TO: Mayor J. Clark Boddie, City of Palmetto
ATTN TO: Cindy Hanson, City Clerk, City of Palmetto
RE: Development of Regional Impact Review
FROM: Mike Alexander, Center for Livable Communities, Atlanta Regional Commission

Name of Proposal: Merrill Park DRI 3488

MERRILL PARK DRI
City of Palmetto
Natural Resources Group Review Comments
April 12, 2022

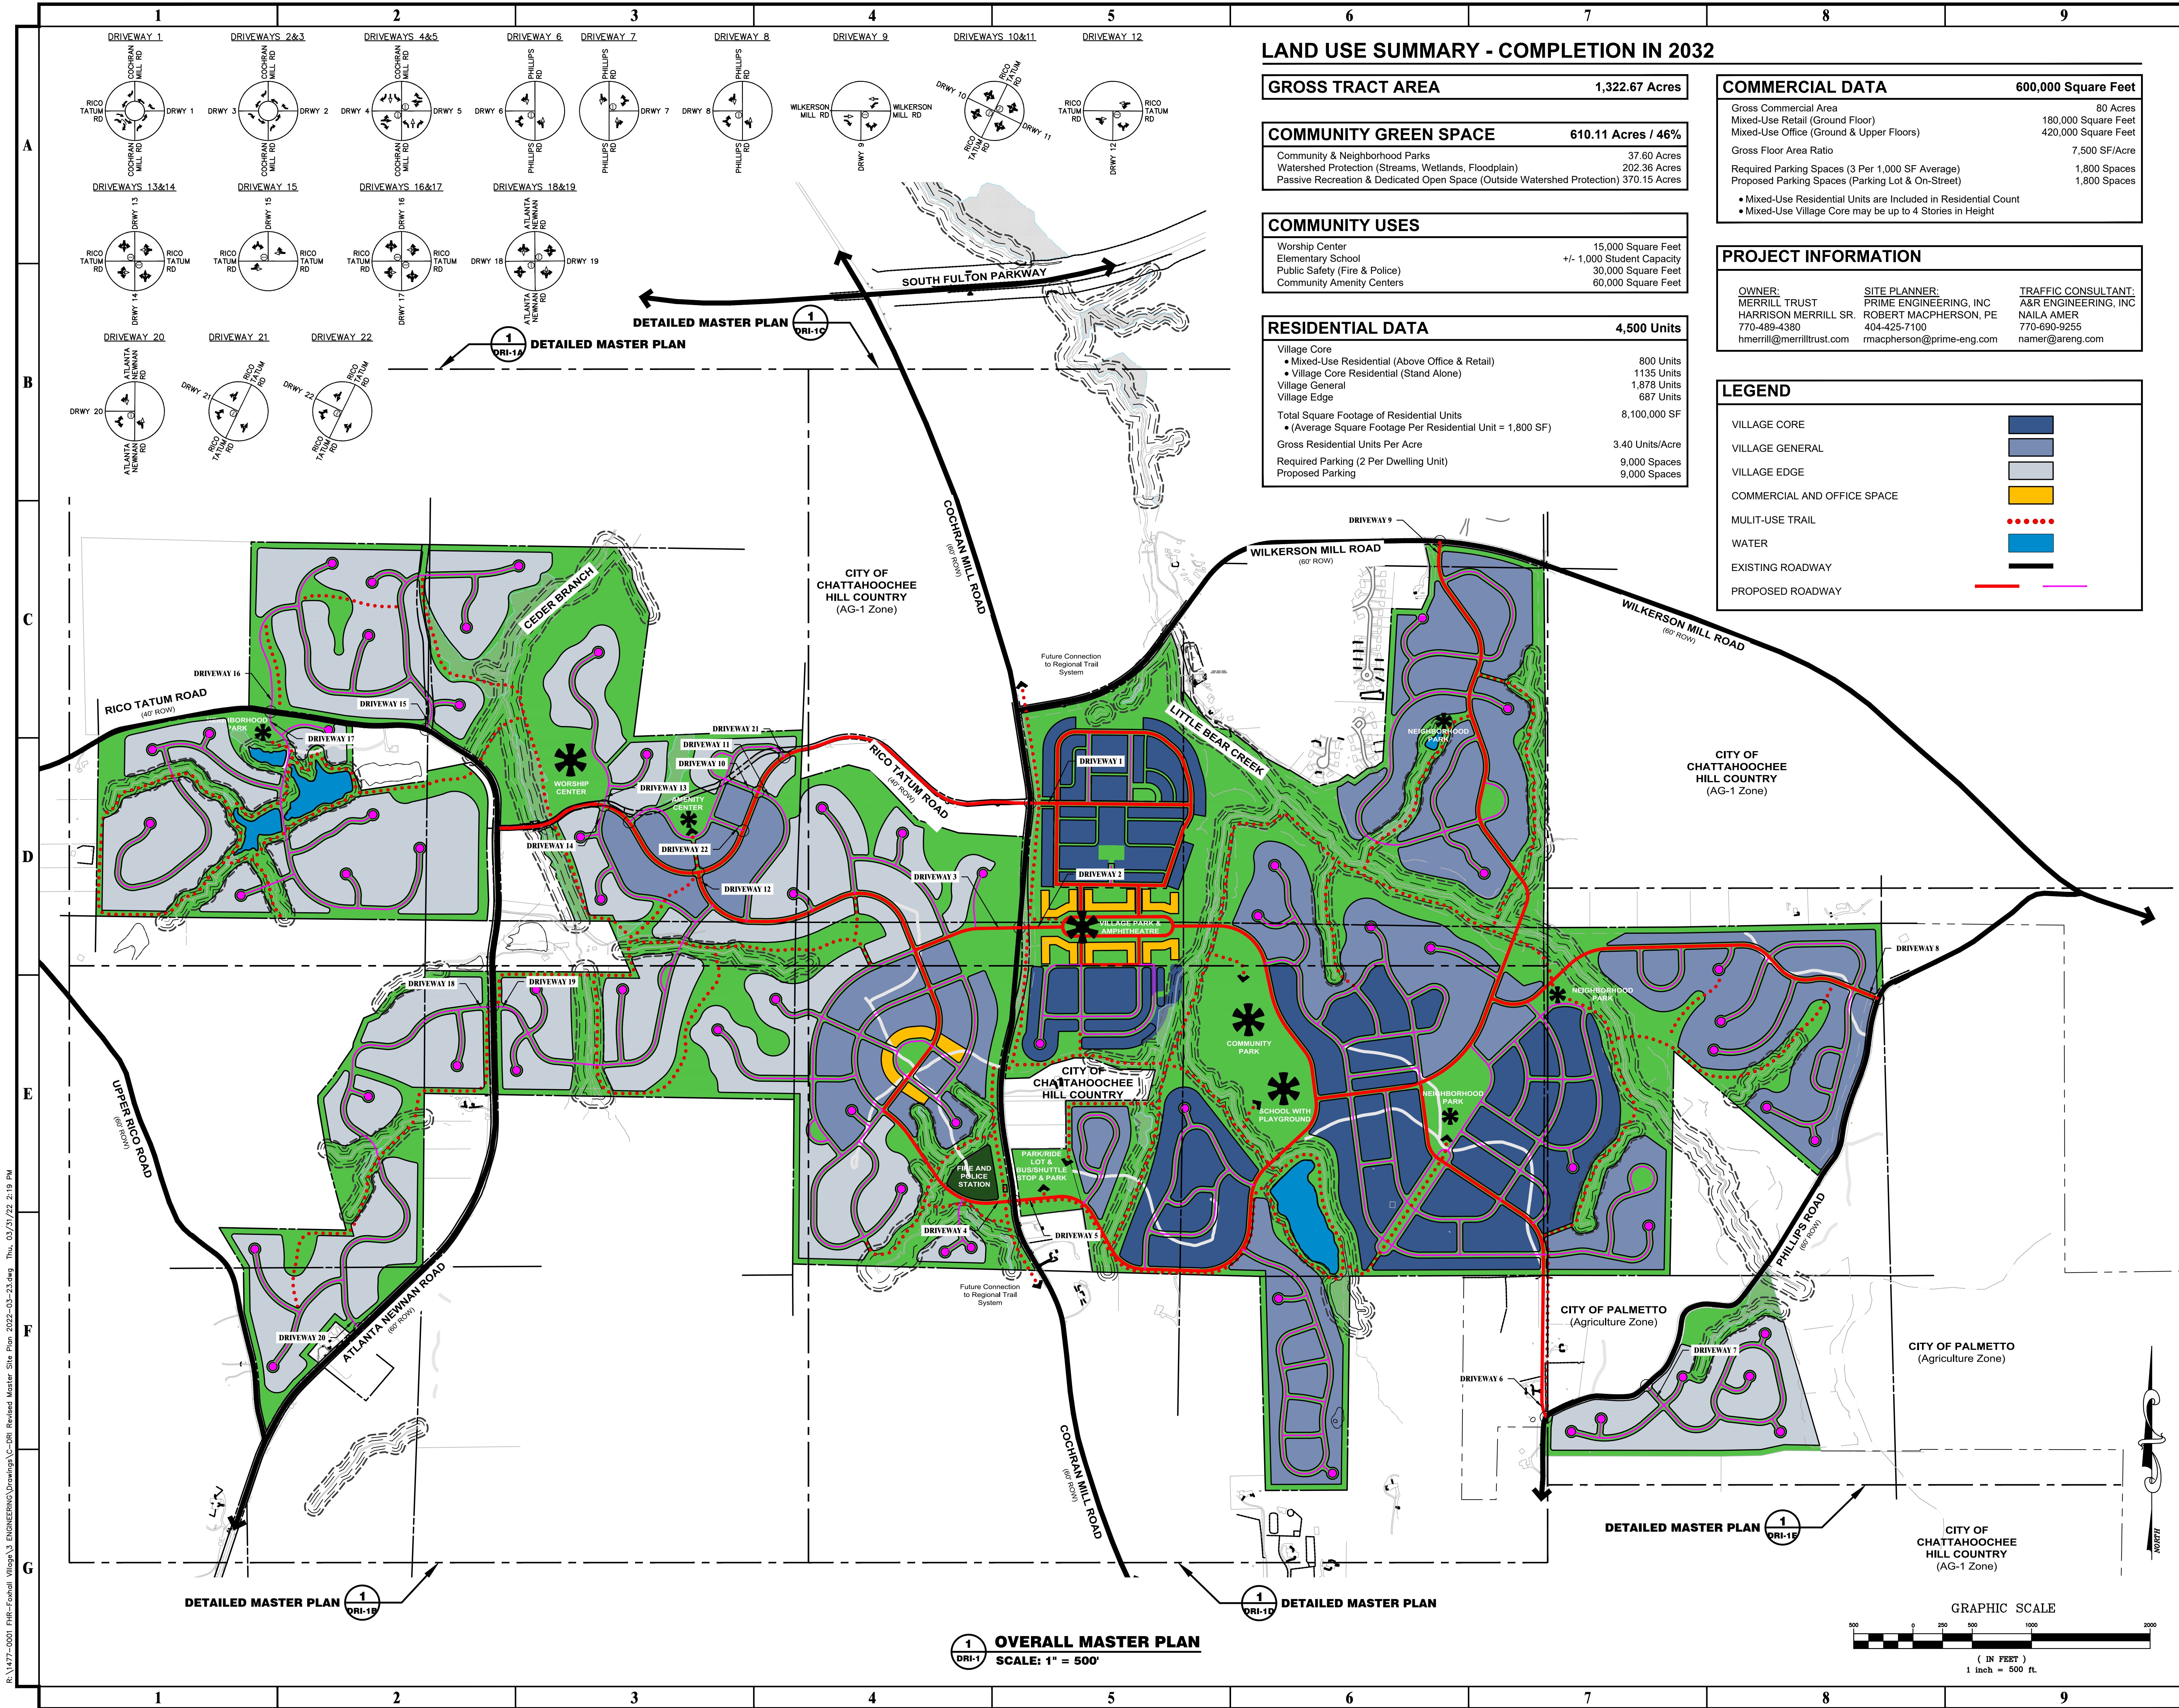
The USGS coverage for the project area shows Little Bear Creek, Cedar Branch and numerous unnamed tributaries throughout the project property. The submitted project site plan shows these streams, as well as several smaller tributaries throughout the property. All show the 50-foot undisturbed buffer and the additional 25-foot impervious surface setback required under the City of Palmetto Stream Buffer Ordinance. The State 25-foot Erosion and Sedimentation Buffer is also shown. No intrusions into any of the buffers are shown. Any unmapped streams may also be subject to the Palmetto Stream Buffer Ordinance. Any other waters of the State on the property are also subject to the 25-foot state Erosion and Sedimentation Act buffers.
